## **AS BUILT DRAWING**

D2019-00162

## AUDIO VISUAL SYSTEM

BLOCK 2 - LEVEL 3 MEETING ROOM 03-07

BLK 2 - LEVEL 3 MEETING ROOM 03-07 SCALE 1:100

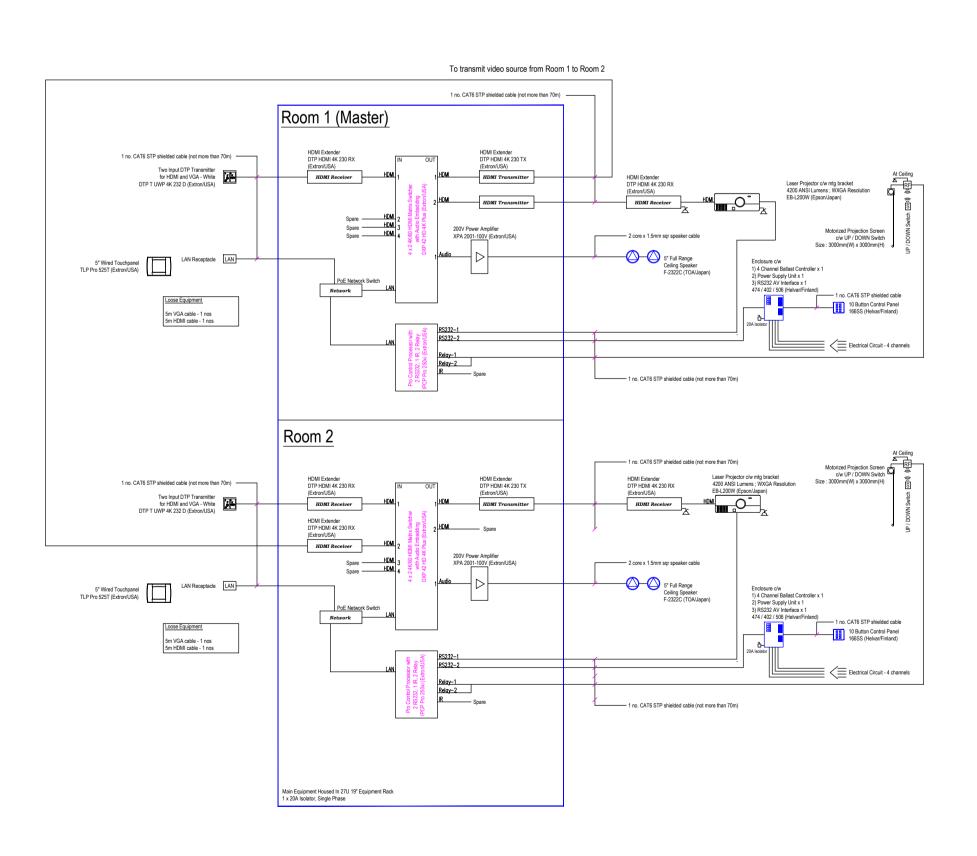
> Commented to add 1 more projector. Added 1 projector, 1 screen, 1 set of DTP hdmi extender. Upgrade the control processor from IPCP PRO 250xi to IPCP PRO 350xi.
